**CERTIFICATE OF APPROPRIATENESS**

**Applicant:** Chip Fucik, Architect for Paul and Melinda Moak, owner

**Property:** 3395 Del Monte Drive, Lot 1, Block 8, River Oaks Country Club Estate Subdivision. The property includes a landmarked 6,751 square foot, two-story brick veneer residence and attached garage situated on a 22,626 corner lot.

**Proposal:** Alteration – Remove and shutter a single rear facing window of a landmarked structure. Although the windows is facing the rear, the property is a corner lot and the windows is visible from the side street.

**FIRST FLOOR PLAN**  
PROPOSED

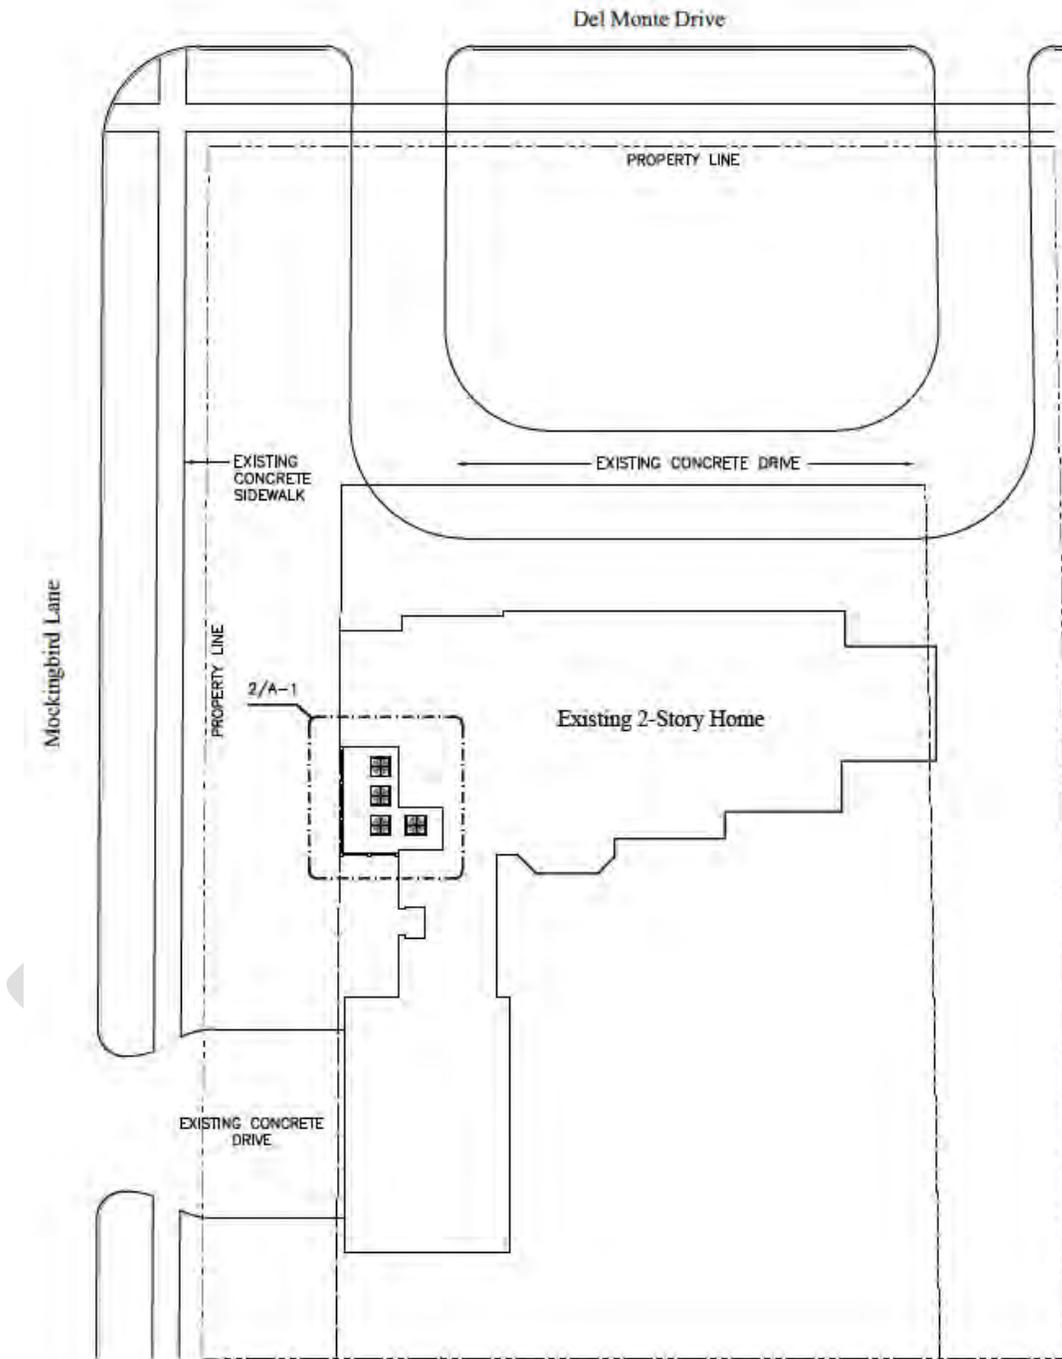
**Windows/Doors:** An existing window, located at the rear portion of the main structure, but visible since the residence is located on a corner lot, will be removed. The window opening will then be covered over with cementitious material and a pair of closed shutters will be installed, matching an adjacent previously shuttered window. The size of the opening will not be altered. See drawings and photos for more detail.
